URGENT INFORMATION SUPPLEMENT
AUTOMATIC NUMBER ANNOUNCEMENT CIRCUIT
NUMBER VERIFICATION
MULTIFREQUENCY RECEIVER TEST

1.1 This UIS is being issued to clarify the test procedure to be followed and to show the proper use of the ITE-4508 connecting cord.

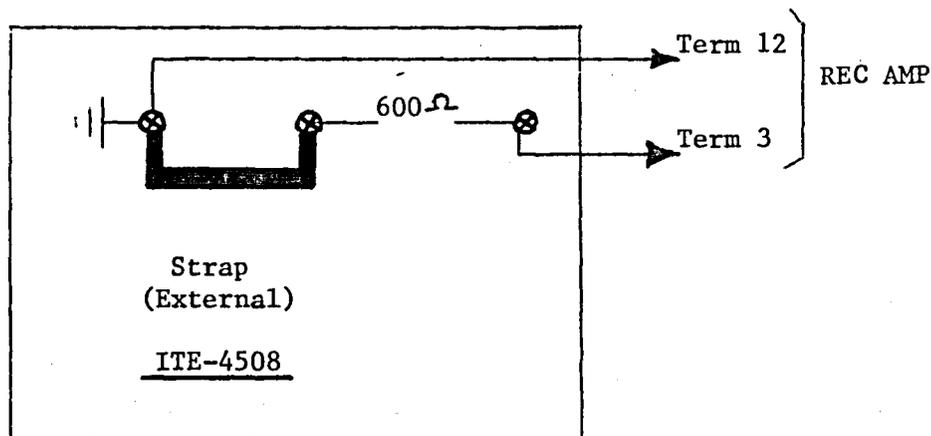
- 2.1 Paragraph 5.13 - Add the following to Step 2 Operation: (OFF position).
- 2.2 Paragraph 5.13 - Add the following to Step 3 Operation: (See Sketch A).
- 2.3 Paragraph 5.13 - Change Step 6 Operation to read: On ITE-4508 Oscillator turn the OSC-AMP control clockwise until-
- 2.4 Paragraph 5.13 - Change Step 6 Observation to read: Between 2V and 6V is read on the ITE-4442A voltmeter.
- 2.5 Add Sketch A-
